APPLICATION NO.	FILING DATE	FIRST NAMED INVENTOR	ATTORNEY DOCKET NO.	CONFIRMATION NO.
09/894,121	06/29/2001	Tsuyoshi Kitahara	Q64938	6181

Office Action Summary

DETAILED ACTION

Attachment A

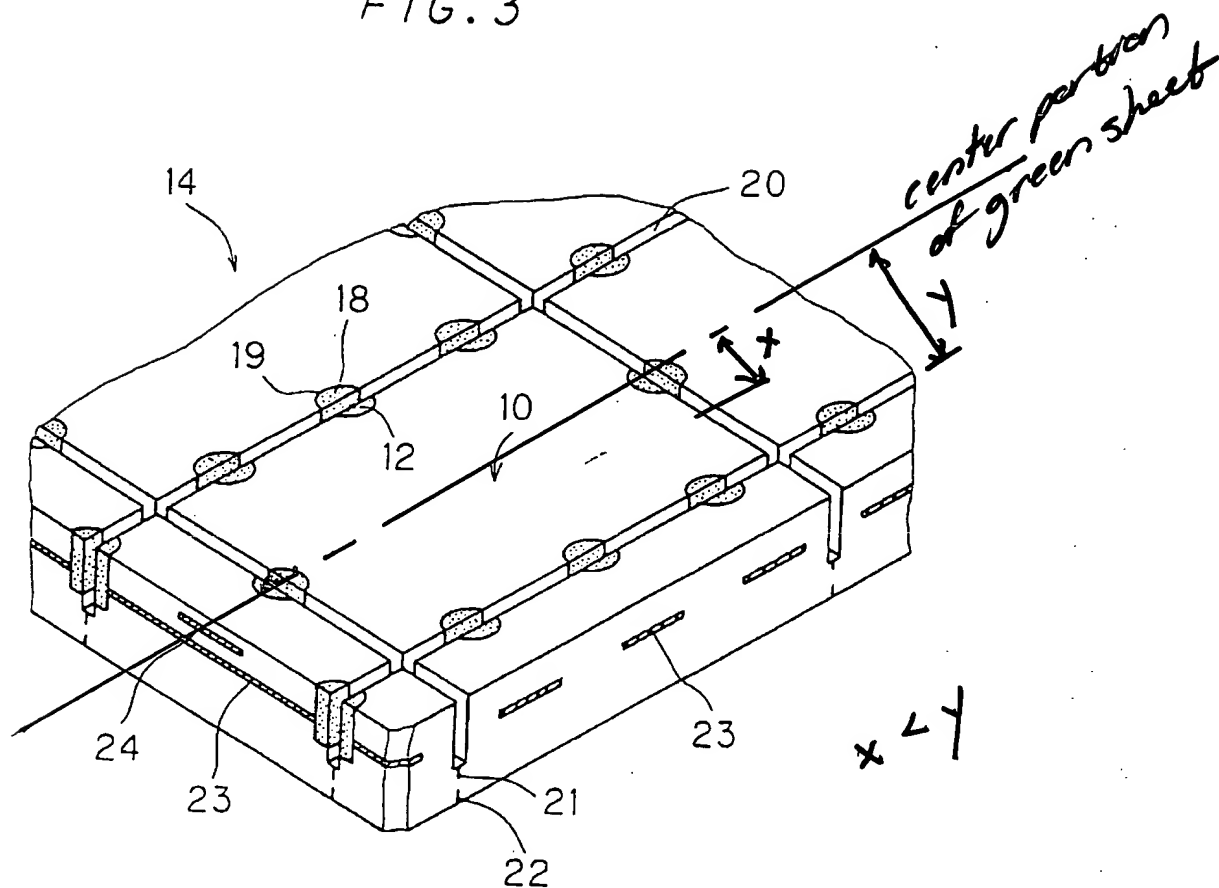
Regarding Claims 21-22, the examiner has provided Attachment A of Kubota's Figure 2, which shows one set of through holes slightly offset from the other set of through holes such that the through holes of alternate layers, or all of the layers, are positioned in one line.

Regarding Claims 23-24, the through holes of Kubota appear to have a greater width than the thickness of the respective green sheet upon reviewing Figure 2. However, if applicants' do not believe that the width of the through holes is larger than the thickness of the respective green sheet, then it would have been an obvious matter of design choice to choose any desired width of the through holes since the applicant has not disclosed that the claimed relative width of the through holes solve any stated problem or is for any particular purpose and it appears that the invention would perform equally well with the width of the through holes taught by Kubota.

Attachment B

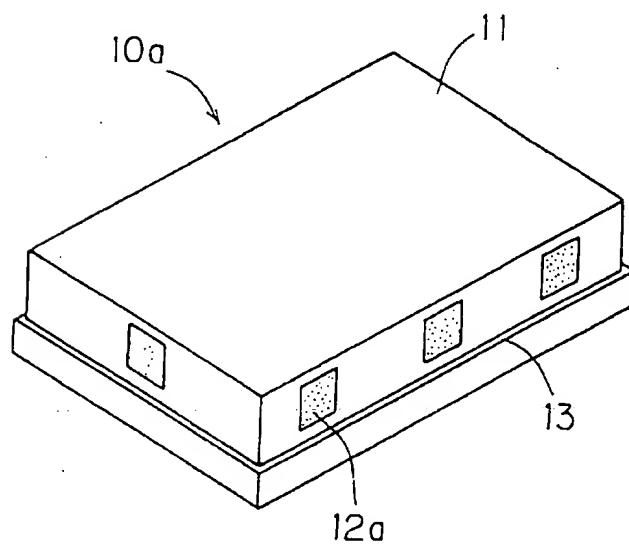
The examiner most respectfully traverses and for further clarification, has provided Attachment B illustrating what is being read as a "strip-shaped non-conductive region" in Kubota's Figure 3. The highlighted region (in yellow) shows a strip-shaped non-conductive region formed on the green sheet that is nearer to a center portion of the green sheet (red dashed line drawn by the examiner) than the through holes formed to the right of the highlighted region.

It is noted that the phrases of "strip-shaped non-conductive region" in "an area" are very broad and relative phrases to describe the relationship of the non-conductive region with the through holes. So broad in fact, that the highlighted region selected by the examiner can satisfy the limitations of the relationship of the "strip-shaped non-conductive region" with the through holes and it appears that further limitations are needed to avoid Kubota.
